From: Franzone, Steve <Steve.Franzone@fpl.com>
Sent: Tuesday, February 14, 2017 3:49 PM
To: Comar, Manny
Cc: TurkeyCOL Resource; Hoellman, Jordan; Maher, William; Orthen, Richard
Subject: [External_Sender] ITAAC review
Attachments: PageC-343_from Turkey Point Unit 6 COL Appendix C-2.pdf; PageC-505_from Turkey Point Unit 6 COL Appendix C.pdf; LCB_4_from PART_10.pdf; PageC-341_from Turkey Point Unit 6 COL Appendix C-3.pdf

We have reviewed the draft ITAAC and have identified several potential editorials items:

Figure 2.6.1-1 (Sheet 1 of 4)
Main ac Power System

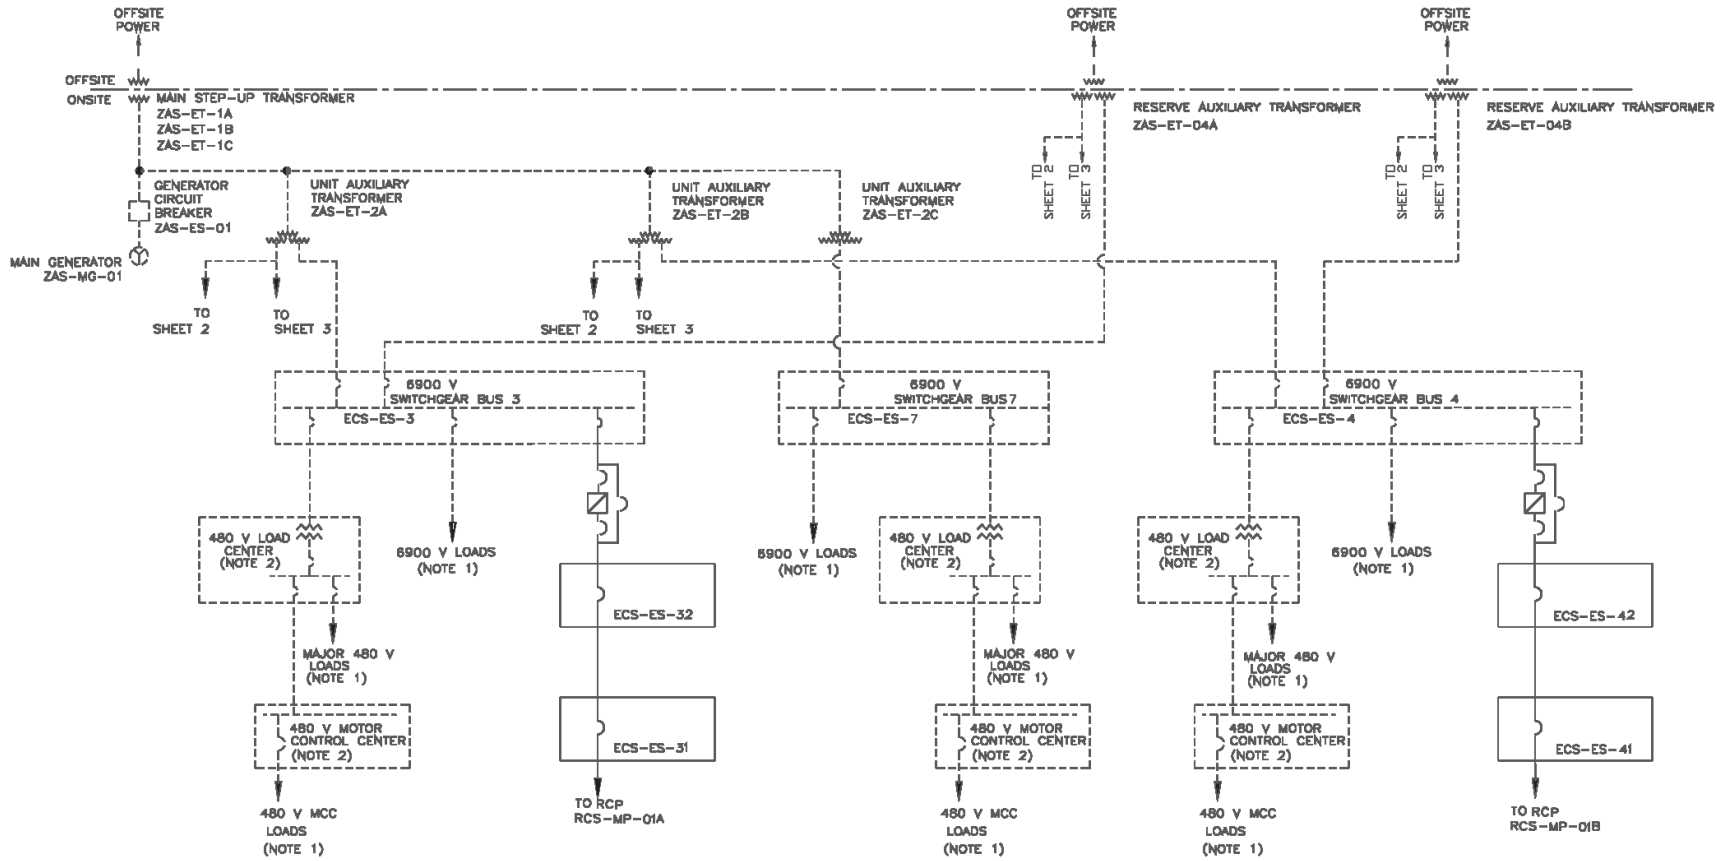
1. Figure 2.6.1-1 (sheet 1 of 4) missing "m" in System, page C-343,
2. Table 2.3.8-4, C.3.8.04.01 - extra "mudmat" removed as compared to our submittal. Page C-505,
3. Table 2.6.1-4, We had identify an Item 4. g) (ref COLA, PART 10 LCB-4) which was to be inserted as a result of NRC bulletin 2012-01 which appears to be missing, page C-341.
